ADDENDUM TWO QUESTIONS and ANSWERS

RE: Addendum for Request for Proposal Number 6905 Z1 to be opened **July 15, 2024**
~~July 11, 2024~~ at 2:00 P.M. Central Time

KUON
Ithaca, NE
2023

INSPECTION REPORT

26

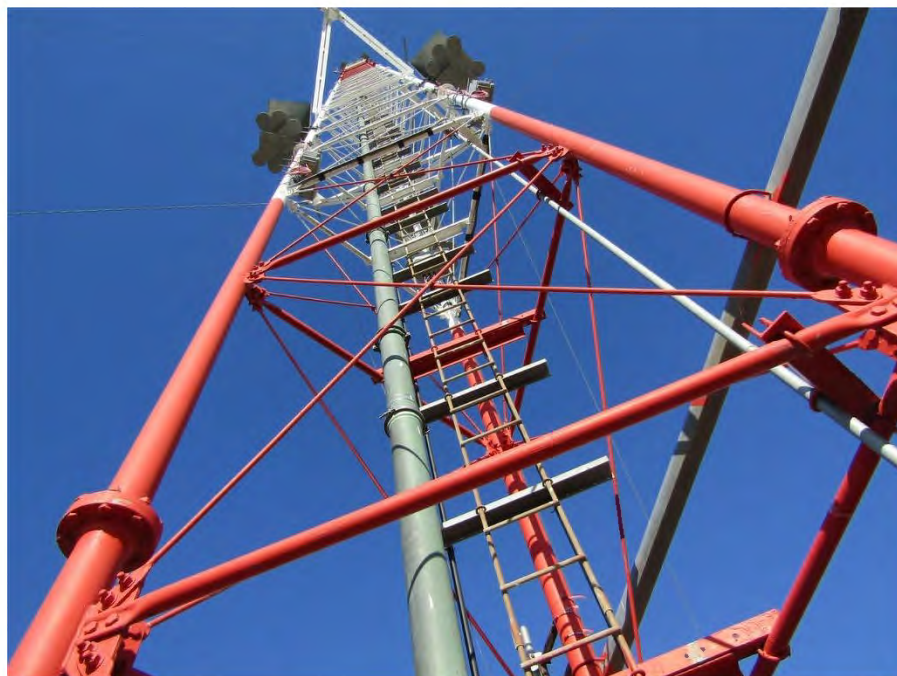
One diagonal member in Section #30, Bay #3, on Face B is bent. We recommend that this member be replaced. ****Priority**

Bent diagonal member in Section #30. Photo also shows loose banding and surface rust at the intersection of the diagonal members.

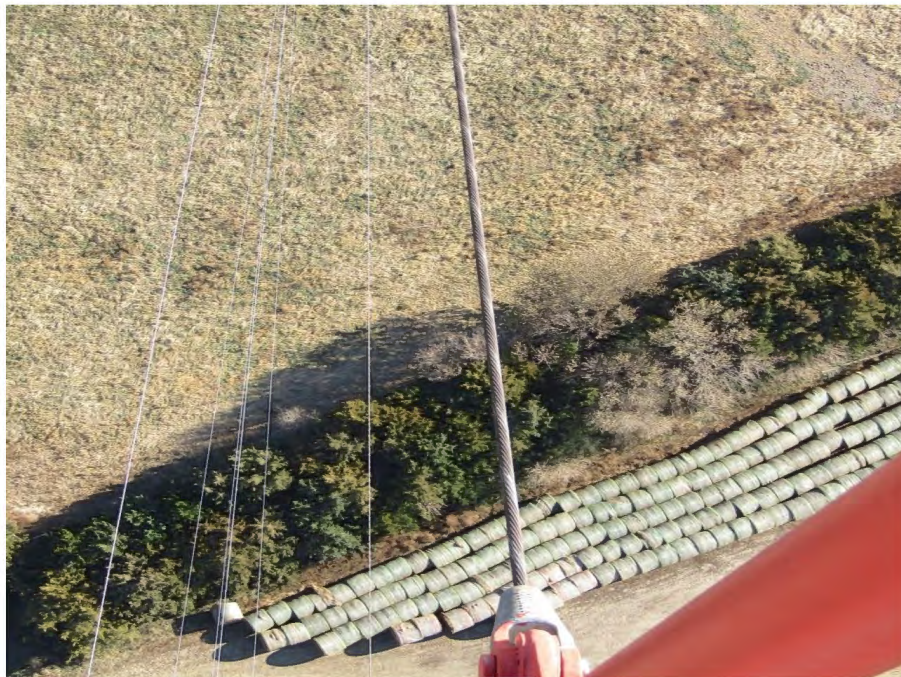
There are areas of surface rust on the guy wires, mostly at the upper elevations of each wire. We recommend treating the guy wires with an anodic self-priming paint or paraffin wax to prevent the progression of the rusting.

Typical areas of surface rust on at the upper end of a level #3 guy wire.

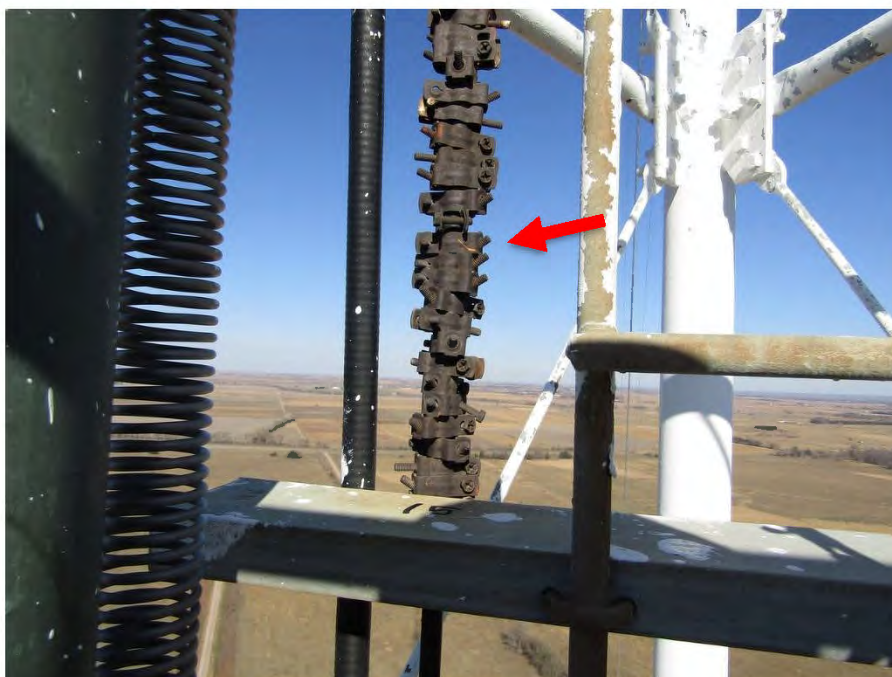
Several cables and flexible lines to ancillary antennas were found to be unsecured at several locations. The lines were temporarily secured with electrical tape and nylon zip ties during the inspection. We recommend that the lines be secured with proper stainless steel hardware, and that the broken hangers that have slid down the line in section #15 be removed.

Flexible line to the dipole antenna in section #20 was unsecured. The line was temporarily secured with electrical tape during the inspection.
